BUILDING CODE OF AUSTRALIA AND ACCESSIBILITY COMPLIANCE ASSESSMENT REPORT

FIVE STOREY MIXED USE BUILDING WITH TWO STOREY BASEMENT

42 NORTH STEYNE, MANLY

REPORT NO. ► 11120 Rev 3.0

FIGURE 2.3 EXAMPLE OF TWO PARKING SPACES WITH A COMMON SHARED AREA—DIMENSIONS FOR AUSTRALIA ONLY*

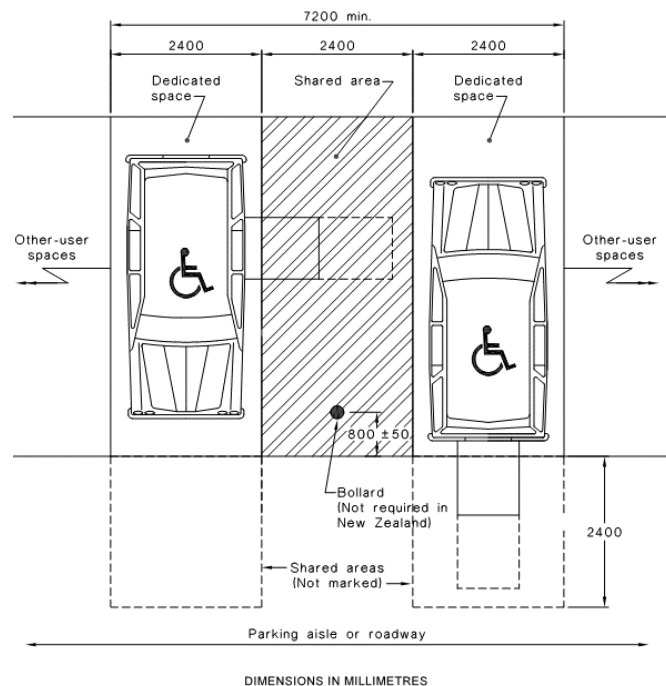
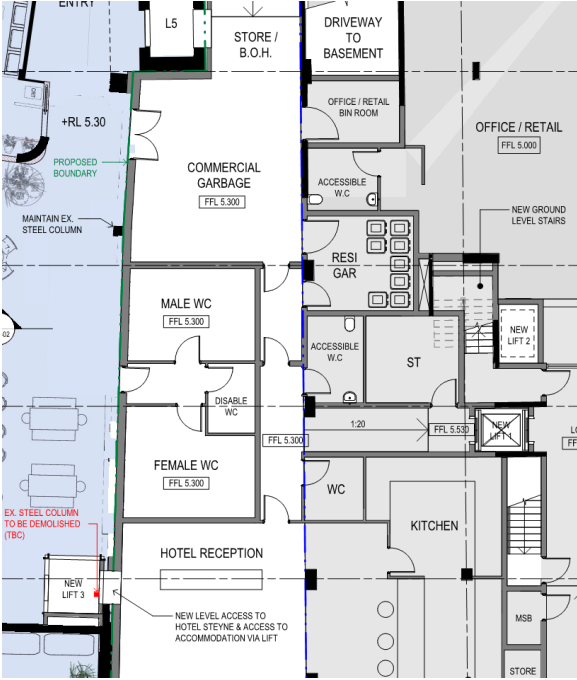
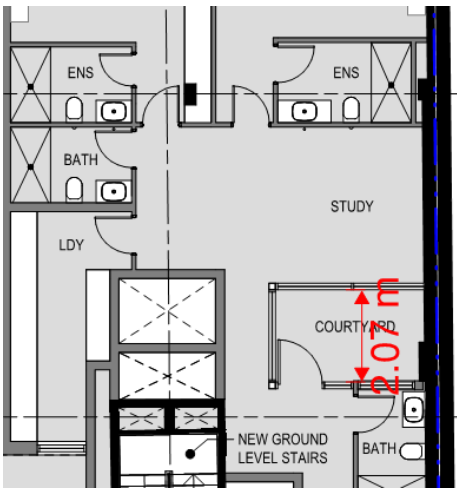
- A structural column is located between the accessible carparking space and the shared zone which does not comply with AS/NZS 2890.6-2009.

This can be addressed by a Performance Solution at CC stage.

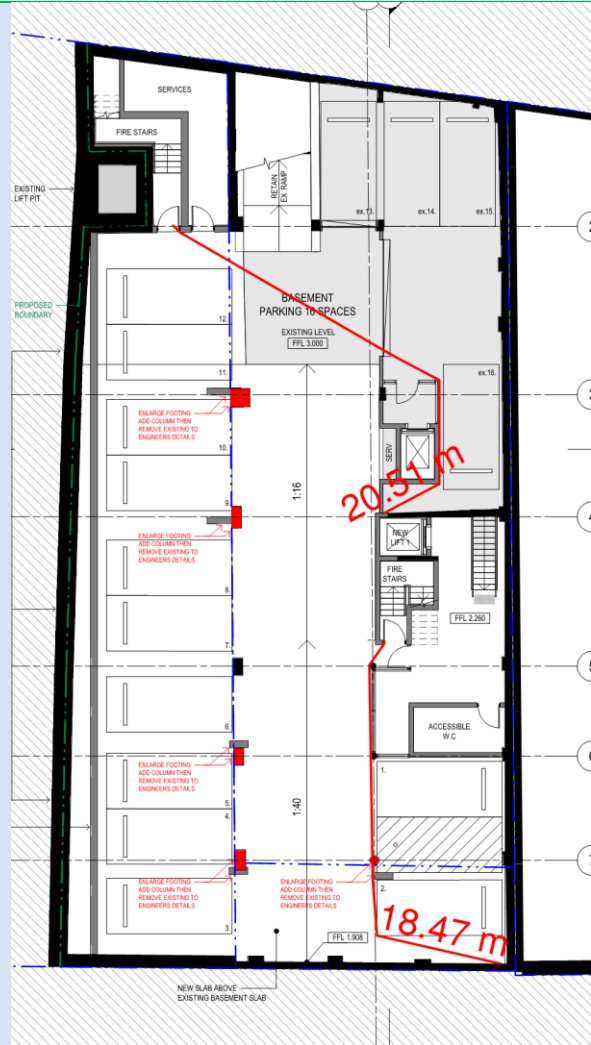
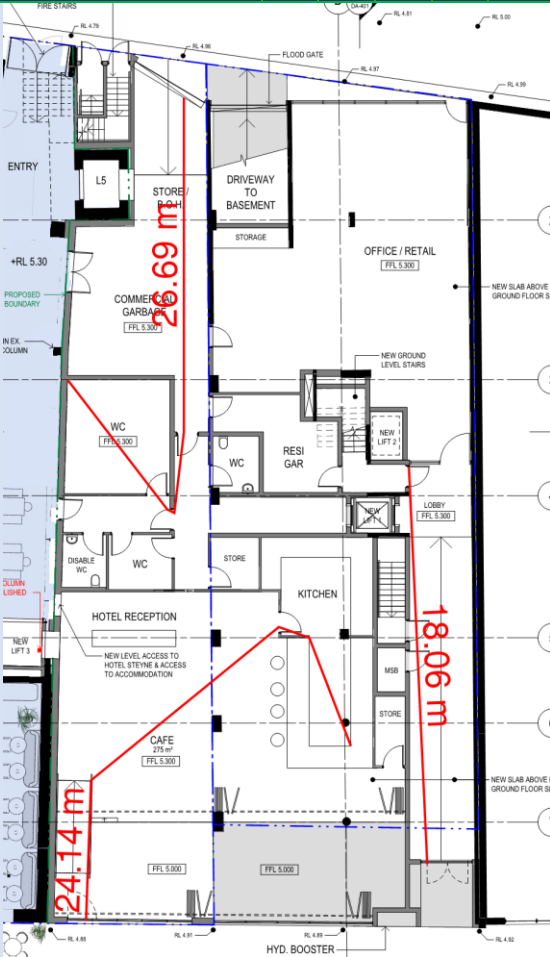
BCA DEEMED-TO-SATISFY PROVISION	COMPLIES	DOES NOT COMPLY	NA or Informational	Compliance Required	COMMENTS
					<p>(ii) in a Class 5 or 6 building, the distance to a single exit serving a storey at the level of access to a road or open space may be increased to 30 m.</p> <p>DTS non-compliance</p> <ul style="list-style-type: none"> Level 2 – Travel distance from the new floor is more than 20m to an exit or a point of choice, being 35.7m.

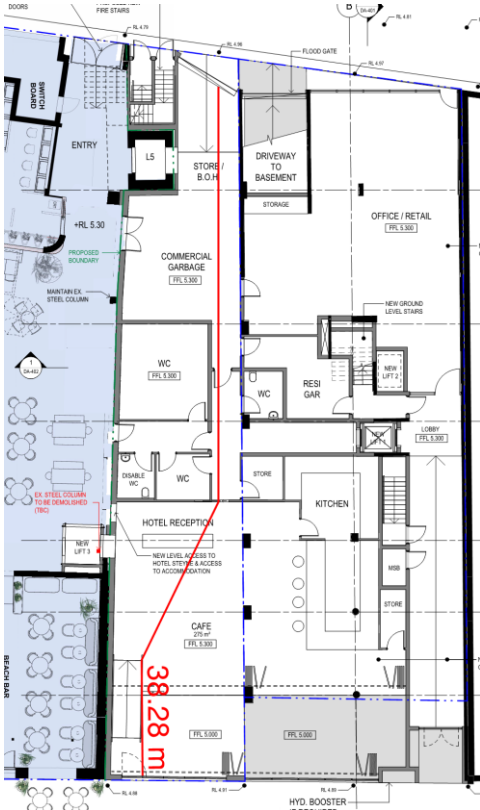
BCA DEEMED-TO-SATISFY PROVISION	COMPLIES	NA or Informational DOES NOT COMPLY	Compliance Required	COMMENTS
 <p>Ground Floor</p>				 <p>Level 1</p>
 <p>Level 2 – Distance to a single exit is greater than 20m.</p>
